The National Grid Company plc

GRID CODE REVIEW PANEL

REVIEW OF BC2 DRAFTING

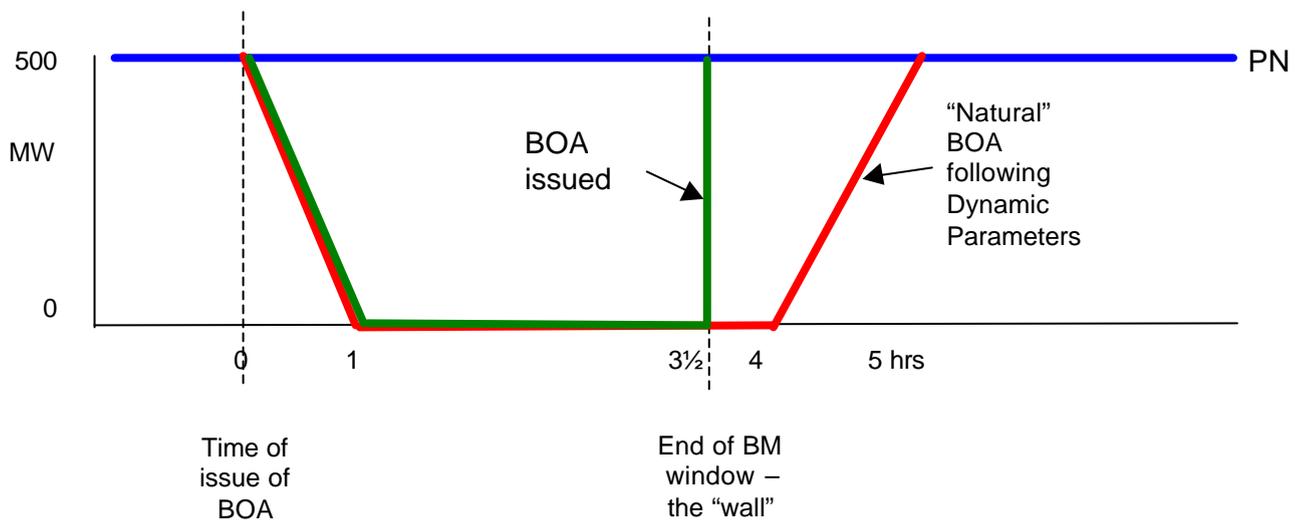
6. As the Balancing Mechanism "Window" is limited to 3½ hrs, then this is the maximum duration of any Bid-Offer Acceptance. Problems arise when the Dynamic Parameters of a particular BM Unit are such that a "closed" Bid-Offer Acceptance would cover a period of more than 3½ hrs. This gives rise to a Bid-Offer Acceptance containing an instantaneous change to PN at the "wall". A simple example will help to illustrate the point.
7. Consider a 500MW exporting BM Unit, with MZT = 3 hrs. Run up and Run down rates implying 1 hr to shut down, 1 hr to run up. The BM Unit submits a "Flat" PN of 500MW. A Bid-Offer Acceptance is issued to shut the machine down.

8. If no subsequent Bid-Offer Acceptance is issued, then at the end of the 3½ hr period, the BM Unit will be left "out of balance" as it will be unable to return to its PN until 1½ hrs later. This situation is not ideal, as it makes BM Participants reluctant to operate openly in the submission of their data.
9. A solution to this issue is being sought, taking account of the likely shortening of Gate Closure time to 1hr. Once a firm proposal has been developed, the Grid Code will be
